**450 Pacific Street (COMPLETE APPLICATION)  
DP-2023-00630 – CD-1**

**EXECUTIVE SUMMARY**

**DEVELOPMENT PERMIT STAFF COMMITTEE RECOMMENDATION: APPROVE**

Figure 2: Proposed plan depicting setbacks and interface conditions

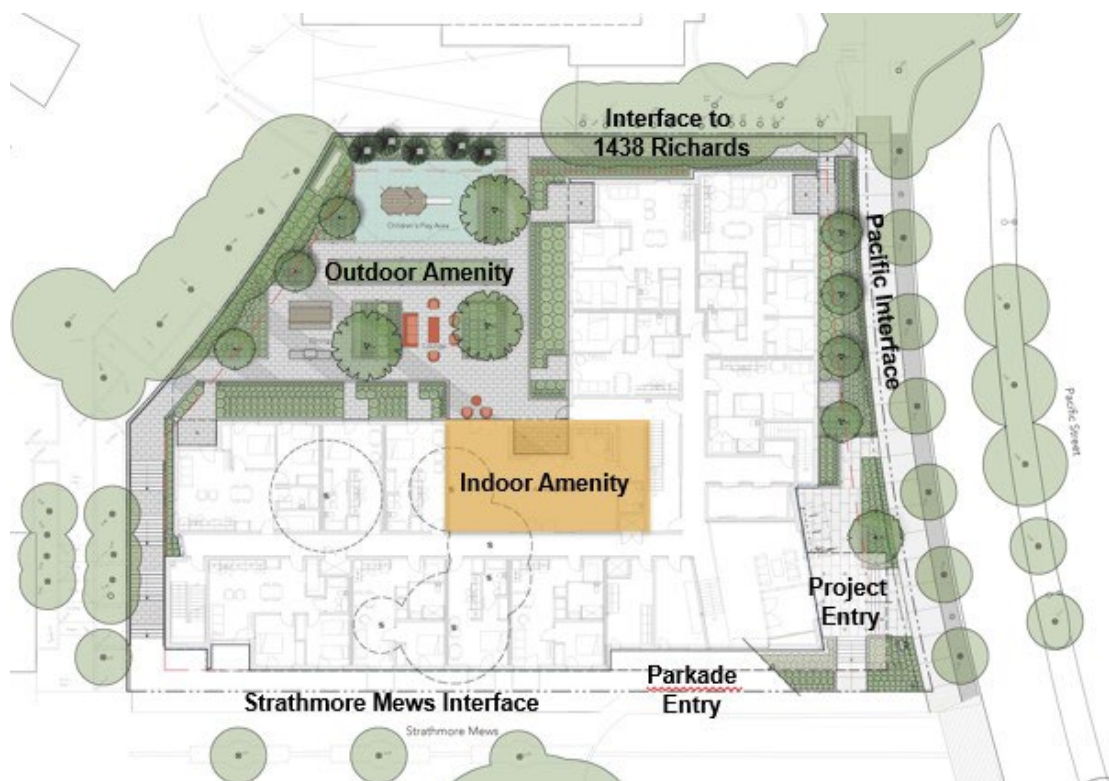
- Pacific Street: Staff support the setback as it provides approximately 5.5 m (18 ft.) from back of curb to the building face, allowing for a semi-private planting buffer on site, along with the public sidewalk and a street tree planting zone. Condition A1.2 provides recommendations to refine the interface at the project entry.
- Strathmore Mews: The setback aligns with the *CD-1 Guidelines*. To address UDP commentary, Condition A1.1 provides recommendations to further refine the interface (see Figures 2 and 3).

- Residential northwest side yard: Staff support the 2.65 m (9 ft.) setback as it delivers a total of 8.5 m (28 ft.) building separation to respond to the unique characteristics of the site and is similar to the lane condition across the street between 431 and 499 Pacific Street developments. Additionally, a large outdoor landscape area is proposed at the south of this interface to create sympathetic views from the neighbourhood buildings. Unit layouts mitigate overlook by restricting side yard views, and landscape provides additional screening.
- Residential southern side yard: Staff support the 2.7 m (9 ft.) as it allows approximately 7.5 m (25 ft.) between buildings. There is minimal impact on the adjacent low-rise townhouse units.

Figure 4: Aerial perspective depicting proposed 7-storey building form

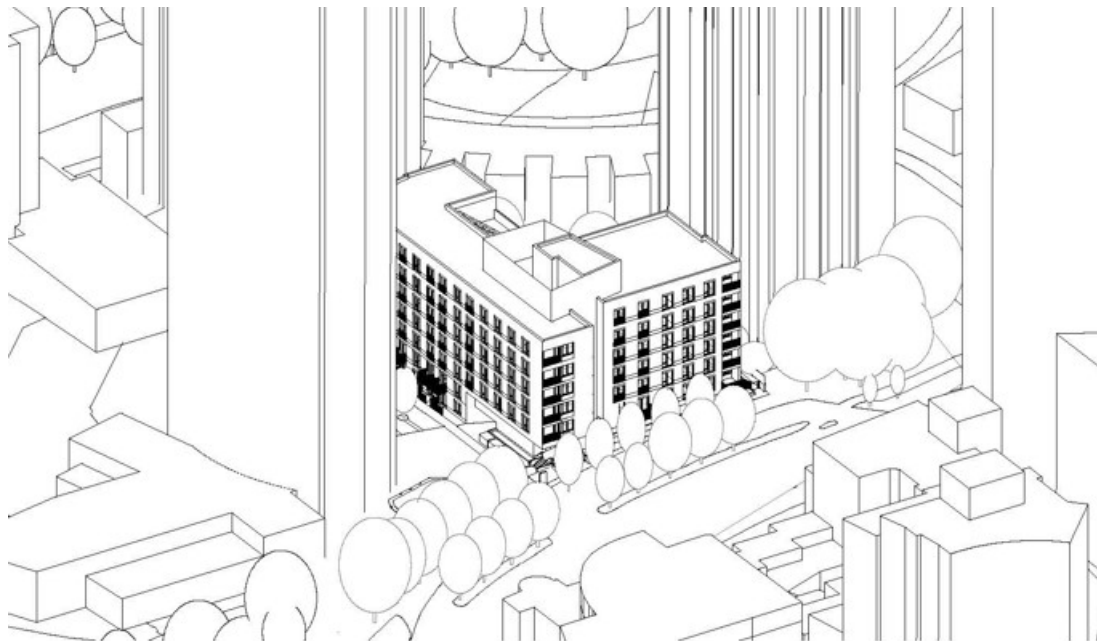
**Applicant's Response:** To maximize the delivery of social housing units, the L-shaped building proposes 7 storeys at both Strathmore Mews and Pacific Street frontages (see Figure 4.)

The proposal provides a low-rise, L-shaped building typology and large courtyard as per the *CD-1 Guidelines*, along with cost-effective wood-frame construction. Noting that Section 5 allows for relaxations to the building massing for social housing, the 7 storeys on Strathmore Mews is supportable. Also, Pacific Street has a generous right-of-way (approximately 115 ft.), and thus the increased height to 7 storeys is supportable.
